CITY OF DOVER, DELAWARE
PLANNING COMMISSION
Monday, April 17, 2023 at 7:00 PM

AGENDA

3. S-23-06 College Road Apartments at Railroad Avenue/Grove Street – Continued Review of Site Development Plan for construction of two 6-story mid-rise apartment buildings with a total of 385 units consisting of studio, 1 bedroom, and 2 bedroom units. The ground level of each apartment building is parking and the other site improvements include six 7-car garage buildings, parking lots, landscaping, and recreation areas. The Project also includes street construction/improvements to Raymond Street and Railroad Avenue. A Lot Consolidation Plan will combine the four parcels located east of Railroad Avenue for a total of 31.08 acres of land. These properties are zoned RG-5 (General Residence Zone for Mid-Rise Apartments). The subject area is located north of, but not adjacent to College Road, and east of the Railroad corridor in the vicinity of Raymond Street, Railroad Avenue, and Grove Street. Property Owners: Patel College Properties, LLC and Patel Excess College Road, LLC. Tax Parcels: ED-05-067.00-02-53.00-000, ED-05-067.00-02-54.00-000, ED-05-

CITY OF DOVER PLANNING COMMISSION
MARCH 20, 2023

SHEET 7 OF 10

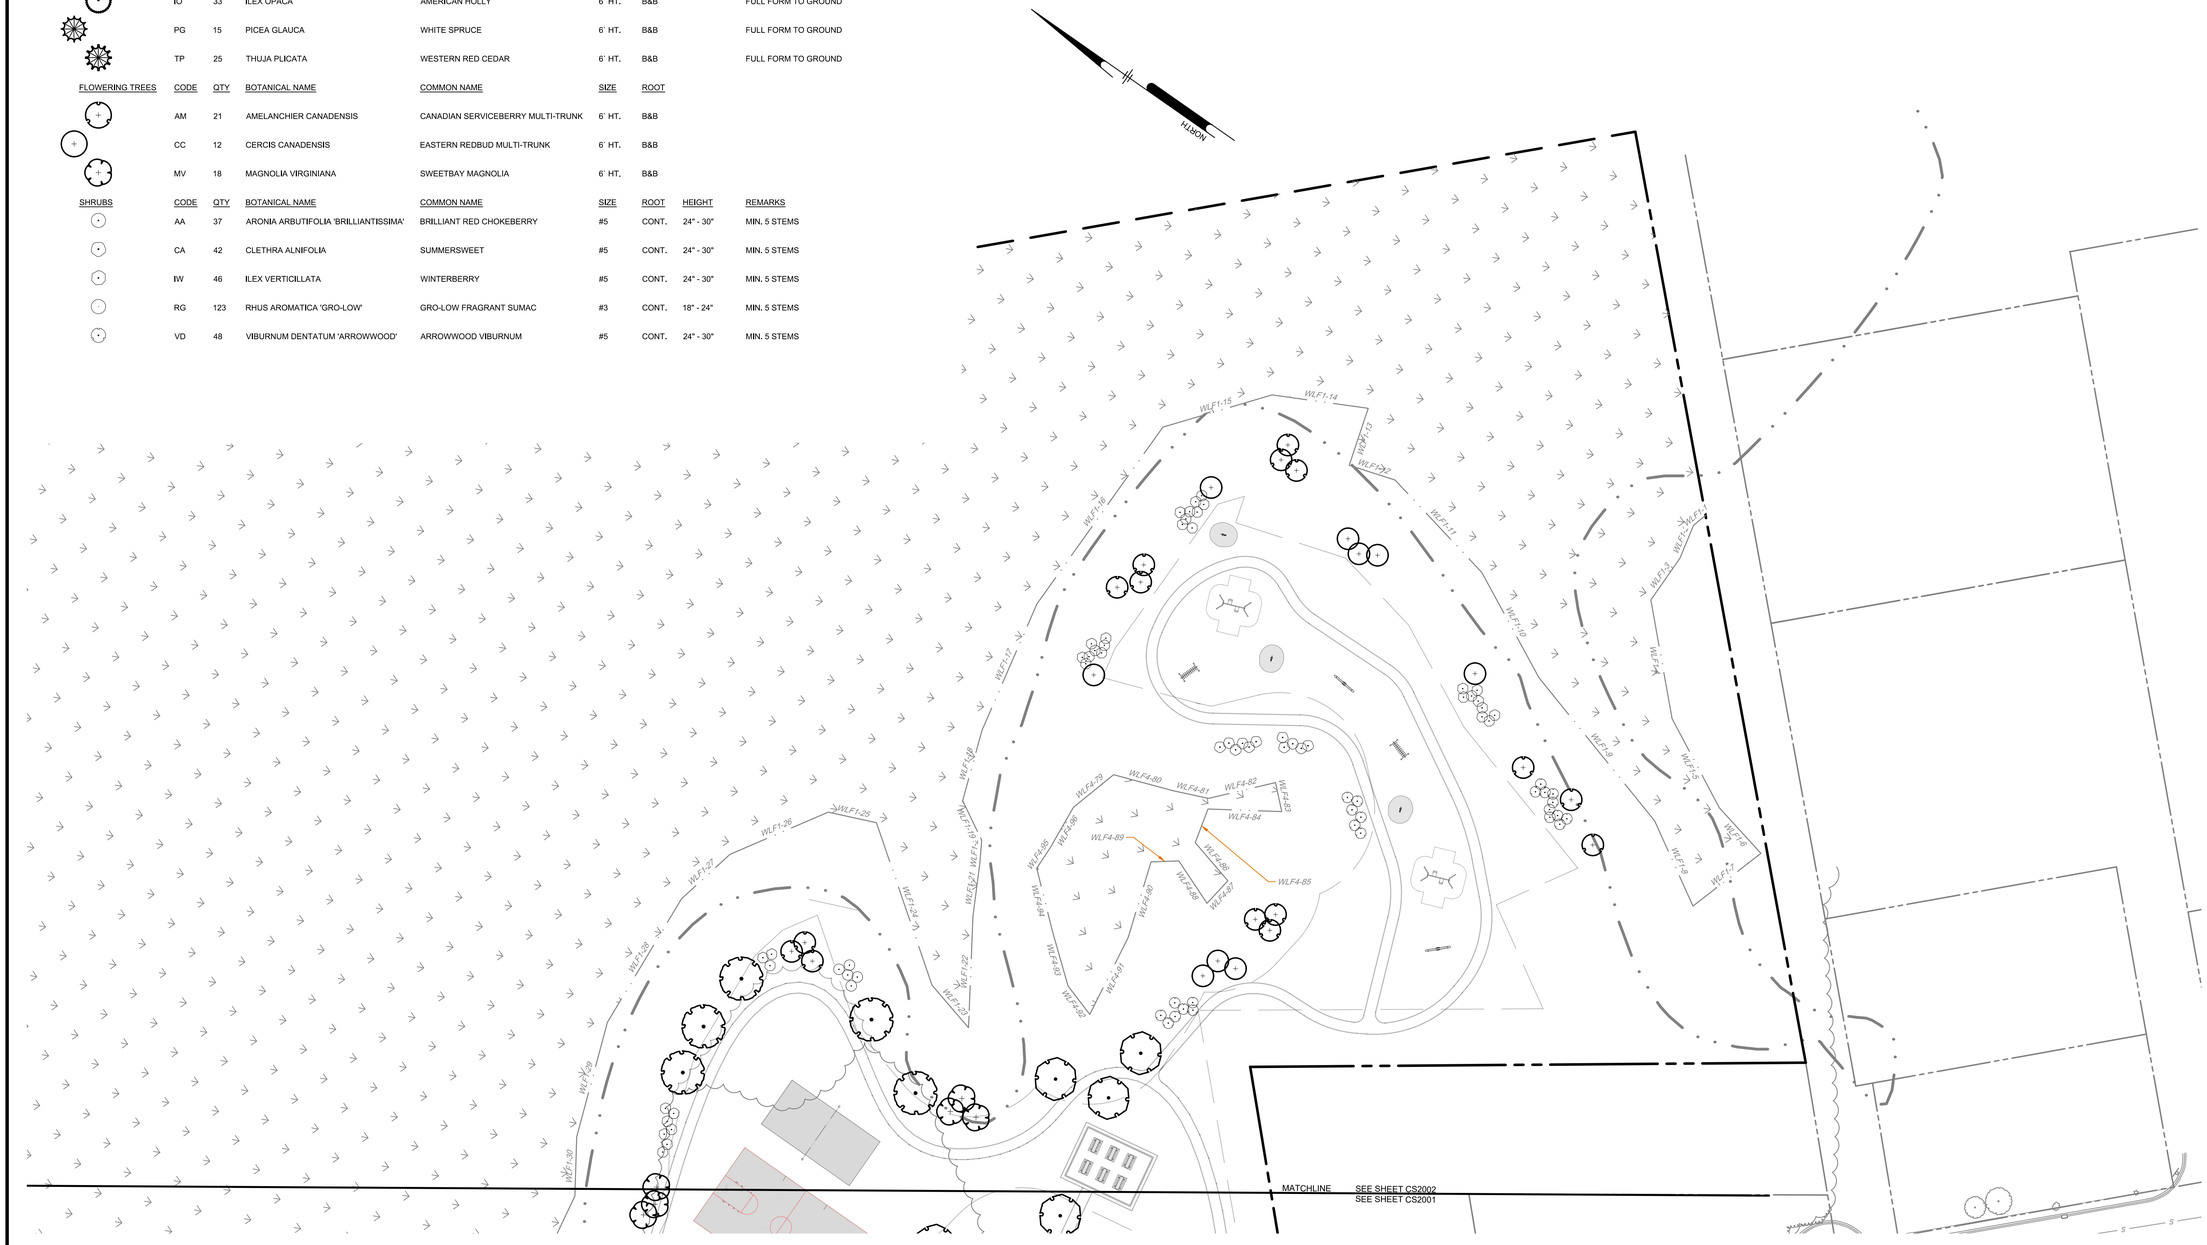
7) Sheets 7 and 8 –Landscape Plan:
   a) Label the tree species on the plan drawings; the use of graphic depictions for each tree specific is difficult to read/review. Also label the shrub plantings for clarity.

OVERALL SITE RECREATION PLAN

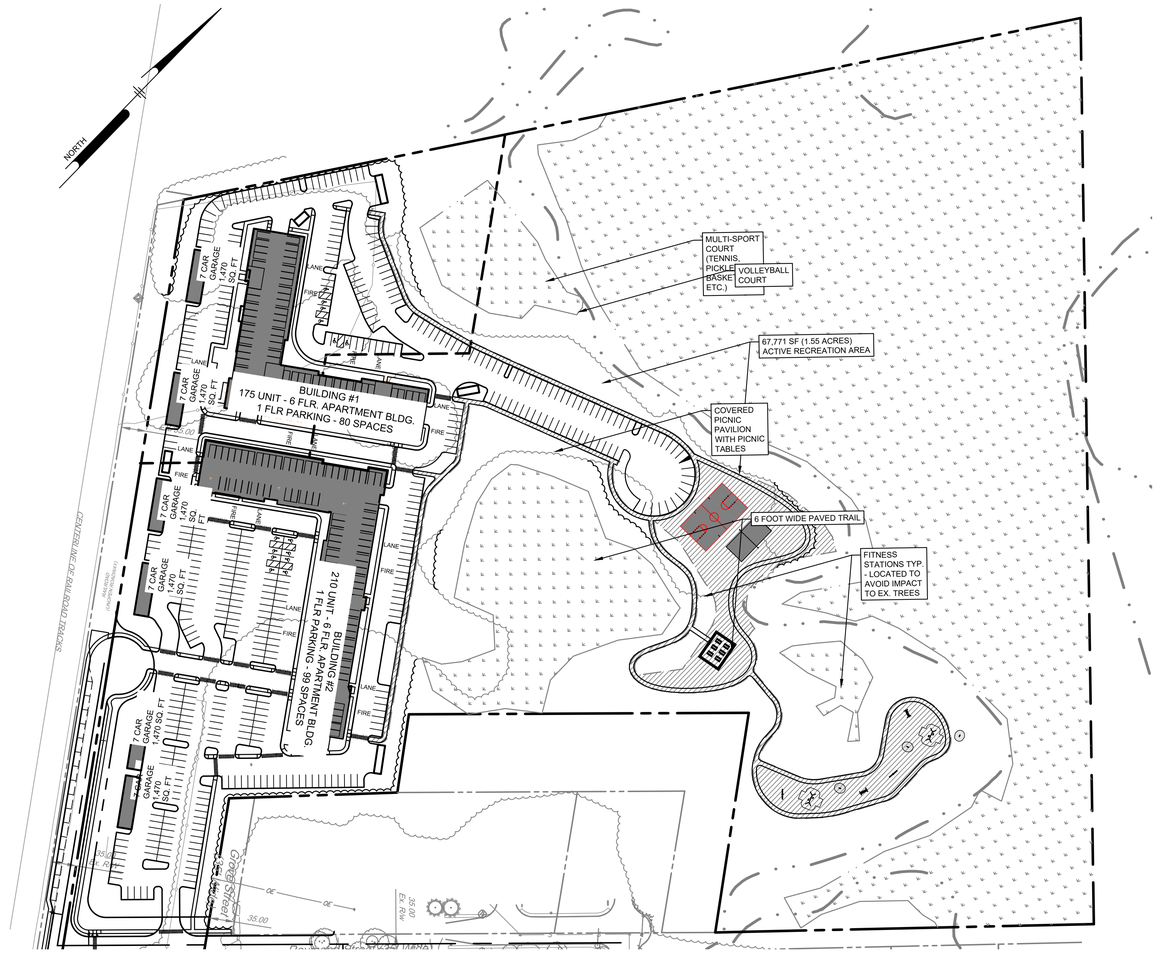
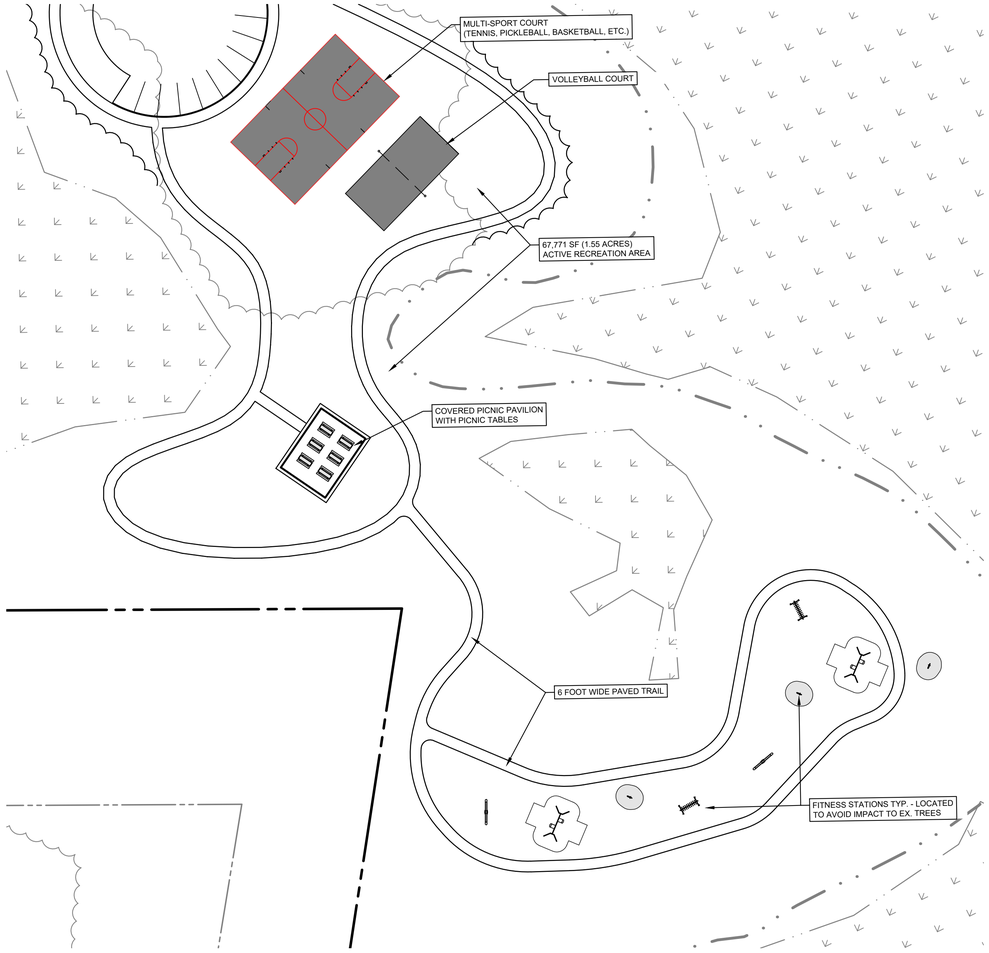
9) Sheet 10 - Active Recreation Area Plan: See Revised Plan Sheet (clarified submission) of March 2, 2023 for current proposal. See the Active Recreation Area Report for review comments.
